## Hui Zhou Gaoshengda Technology Co.,LTD

Ref: FCC Class II Permissive Change for FCC ID: **2AC23-WC0HR2601**

This is to request a Class II permissive change for FCC ID: **2AC23-WC0HR2601**, originally granted on **02/24/2017**

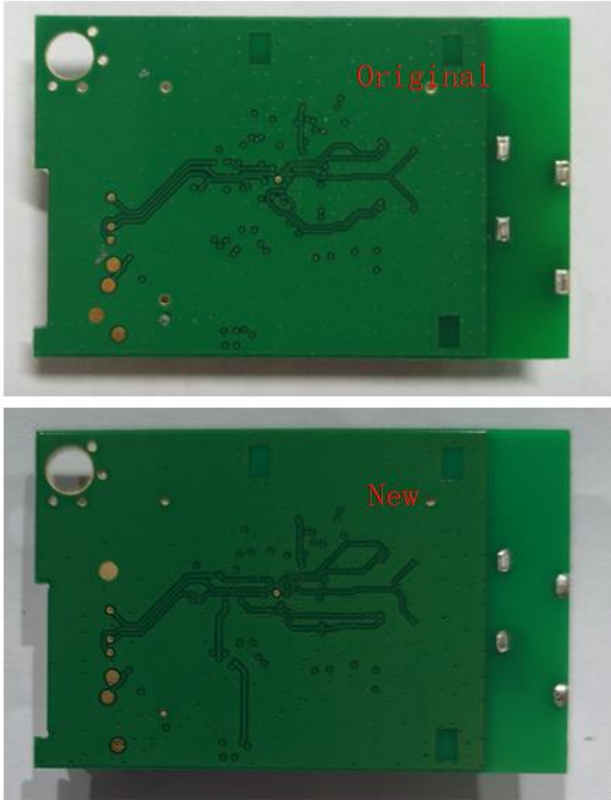
1. Adding DC to DC Circuit. please refer to following photo.

2. The bottom PCB layout has made some adjustments.

3. 2.4G 11n add MIMO function through software settings.  
We performed measurement for Radiated Band Edges, Spurious Emission and Conducted Emission Test and report the worst test data to applied C2PC base on this Module.
